West Parish Filters Water Treatment
Plant
1515 Granville Road
Westfield, MA 01085
Project No. 24-51

ADDENDUM NO. 12 05/28/2024

ADDENDUM NO. 12

Bidders are hereby informed that plans and specifications for the above-mentioned contract are modified, corrected, and/or supplemented as follows, and that Addendum No. 12 becomes a part of the Contract Documents and consists of Item Nos. 12-1 through 12-46.

ITEM 12-34: Section 31 00 01 Earthwork

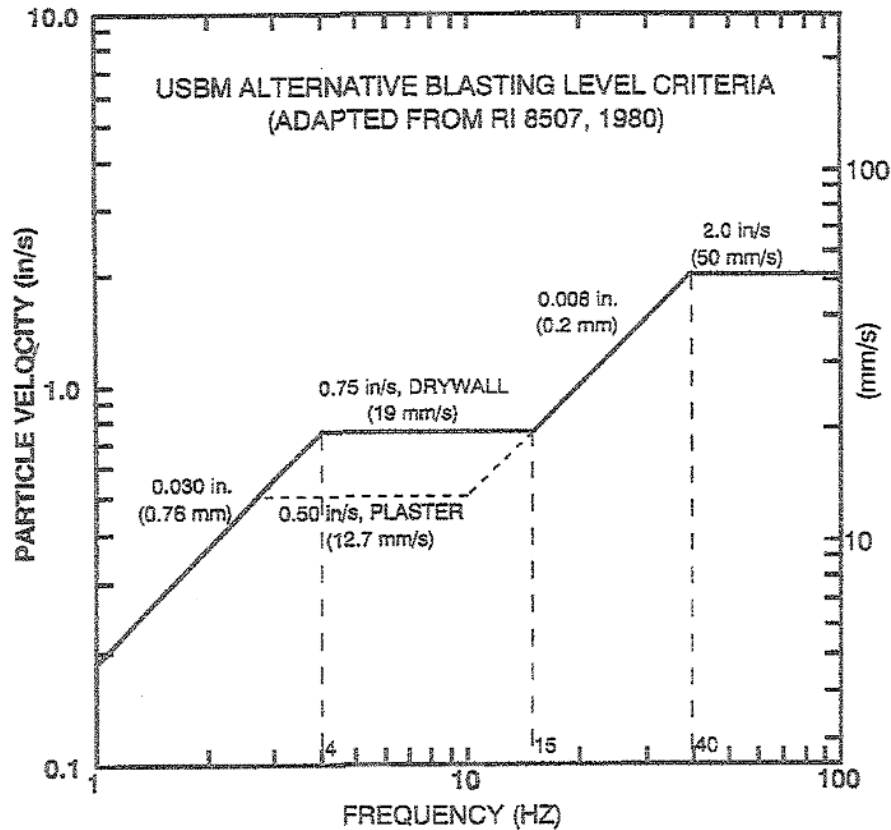
Replace Figure 1 in paragraph 3.02.N.1 with the following:

Attachment A – Figure 5 from 01 41 00.01 BUD Approval

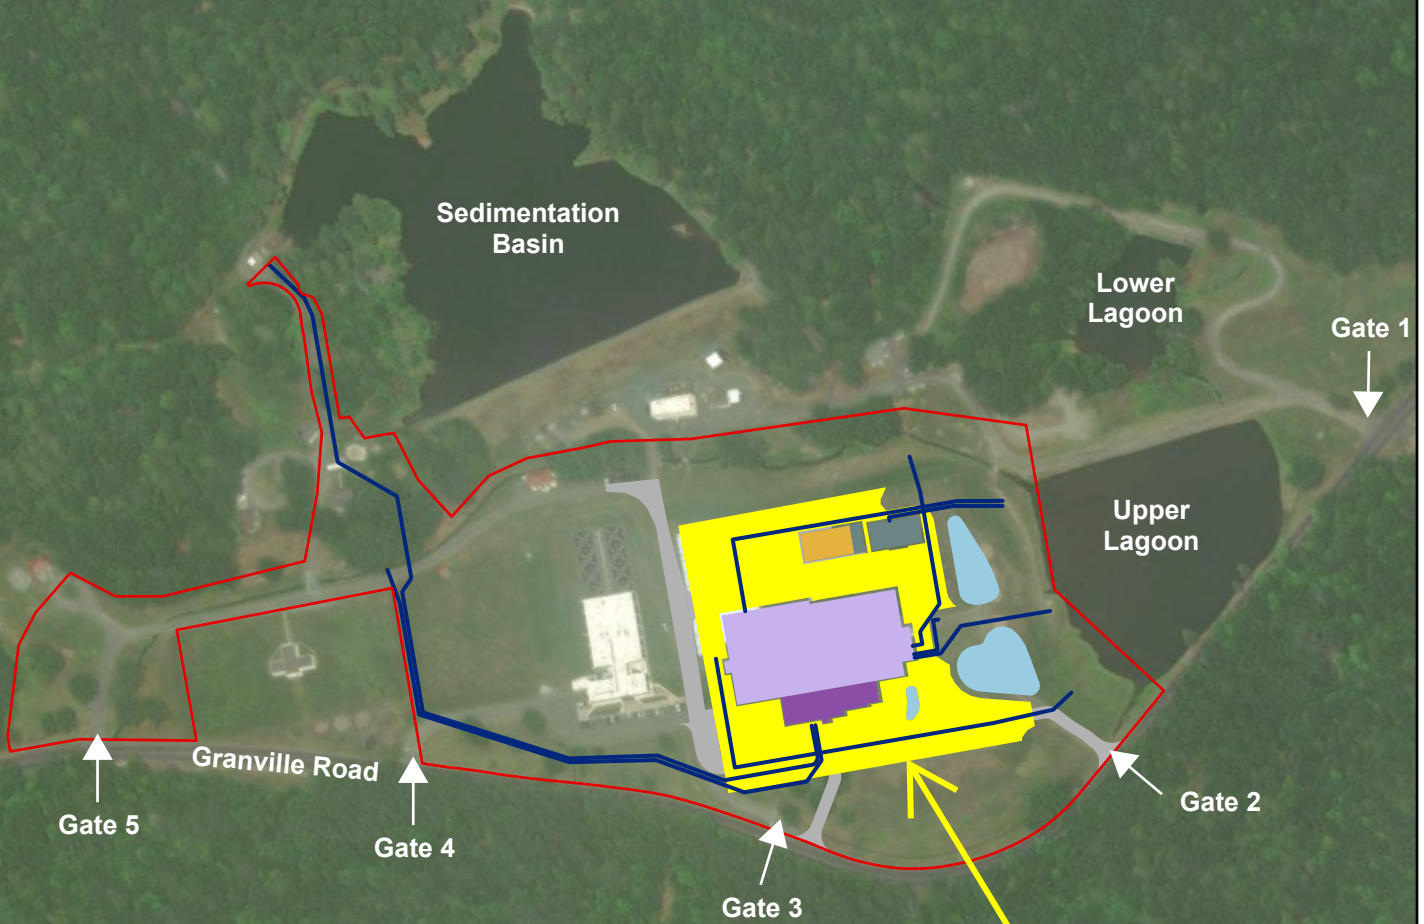
Figure 5 referenced in Attachment 4: Beneficial Use Determination Approval of 01 41 00.01 Schedule of Permits is included as Attachment A.
